FILE INFORMATION:
DIVISION TAB-TRANE REFRIGERATION
PRODUCTS
PRODUCT TAB-RECIPROCATING COM-
PRESSOR-CONDENSER
UNITS
MODEL TAB-HERMETIC M-R
LITERATURE ITEM-SERVICE BULLETIN

HCOM-SB-25

SUBJECT: ROBERTSHAW MOTOR PROTECTOR RELAY DESIGN CHANGE

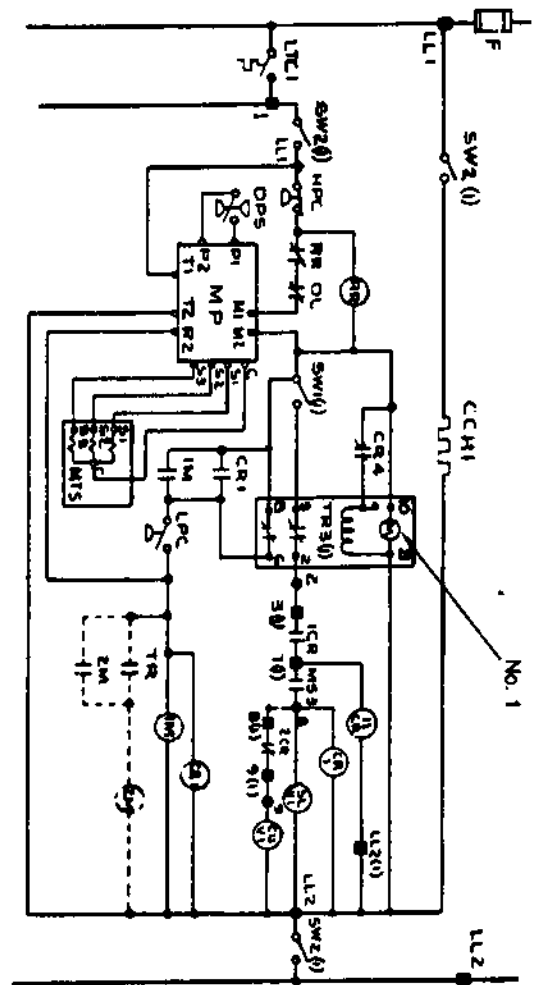
When installed as shown in Figure 1 of Form 1-27.07-1, attached, time delay relay TR10 provides a 0.3 second time delay which allows sufficient time for the M1-M2 contacts of the new style MC-20 to close. This time delay will prevent nuisance lockouts of the reset relay circuit when power is first applied to the control panel or when a momentary power interruption occurs.

The new style MC-20 is physically interchangeable and mounts in the control panel identically as the previous design. The fuse, fuse holder and other parts which ship with the new version, should be connected as shown in Figure 1. The "R2" terminal on the old MC-20 was used to initiate the timing period for the oil pressure circuit in the control. This is now done internally, so "R2" is no longer required on the new MC-20. When replacing an old style control with the new version, the wire previously connected to the "R2" terminal should be removed or the exposed portion secured and insulated using a wire nut or tape.

FIGURE 2

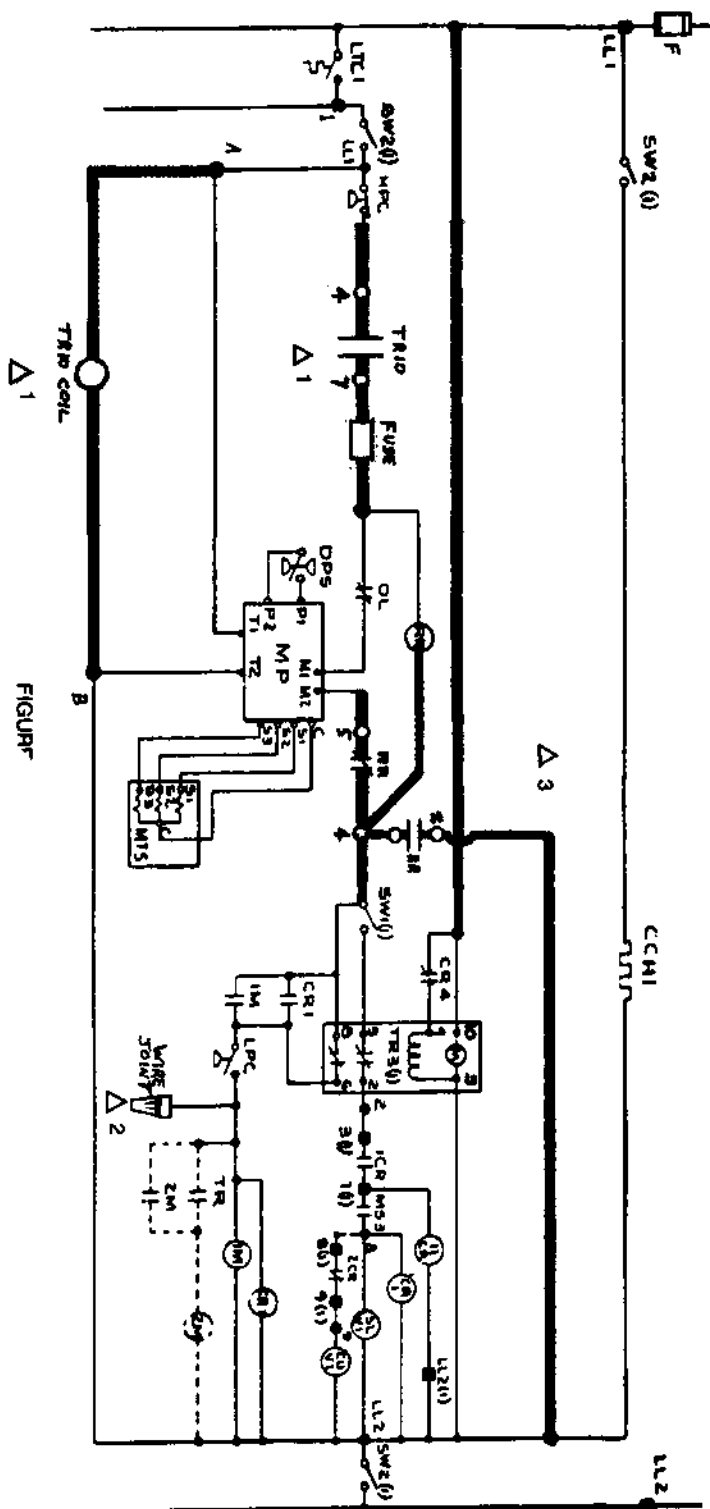
SPECIAL NOTE: When installing a new style MC-20 on duplex Water Cooled Cold Generators (CGWA) equipped with anti-cycle, periodic pumpout, a new reset relay - Trane Part No. RLY-761 will also be required. Refer to Figure 3 of Form 1-27.07-1, attached, for specific details.

Some duplex water cooled cold generators which have an anti-cycle, periodic pump-out timer installed downstream of the M2 as shown in Figure 2 will have nuisance oil
